Project	<b>IEEE 802.16 Broadband Wireless Access Working Group</b> < <a href="http://ieee802.org/16">http://ieee802.org/16</a> >	
Title	<b>Secondary Management Connection Transport</b>	
Date Submitted	<b>2007-01-18</b>	
Source(s)	Peretz Feder – ALU Phil Barber - Huawei	<a href="mailto:pfeder@alcatel-lucent.com">pfeder@alcatel-lucent.com</a> , <a href="mailto:pbarber@huawei.com">pbarber@huawei.com</a>
Re:		
Abstract	Fixes to section 14.2.3	
Purpose	Adoption, Replacing IP signaling with simple payload	
Notice	This document has been prepared to assist IEEE 802.16. It is offered as a basis for discussion and is not binding on the contributing individual(s) or organization(s). The material in this document is subject to change in form and content after further study. The contributor(s) reserve(s) the right to add, amend or withdraw material contained herein.	
Release	The contributor grants a free, irrevocable license to the IEEE to incorporate material contained in this contribution, and any modifications thereof, in the creation of an IEEE Standards publication; to copyright in the IEEE’s name any IEEE Standards publication even though it may include portions of this contribution; and

15 **Figure 477—SMC IP address signaling transport and notification**

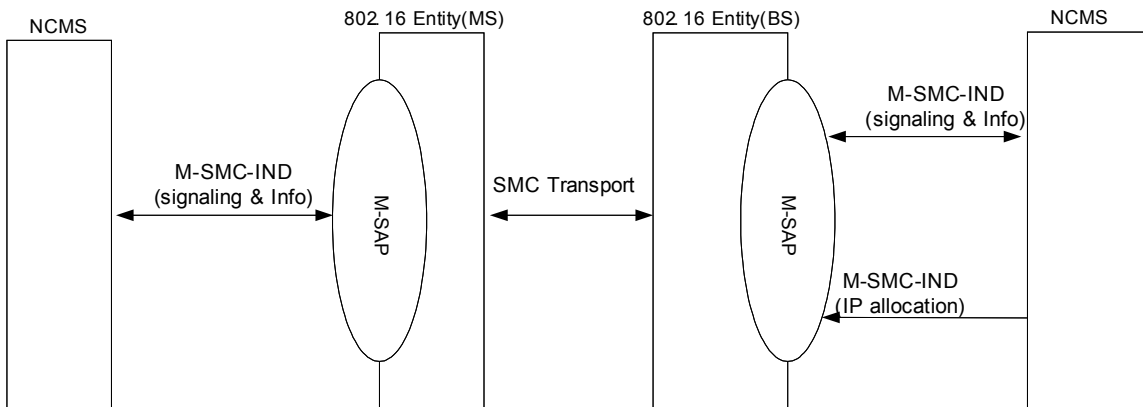
2  
3 Correct section 14.2.3 “IP management with secondary management  
4 connection”. Replace DHCP/MIP and IP address signaling with a generic  
5 payload. Payload may carry IP signaling but no need to be shown in the spec.  
6

10 < Instruction to the 802.16g editor: Existing figures 477, 478, 479 to be deleted  
11 and replaced by the following one. >
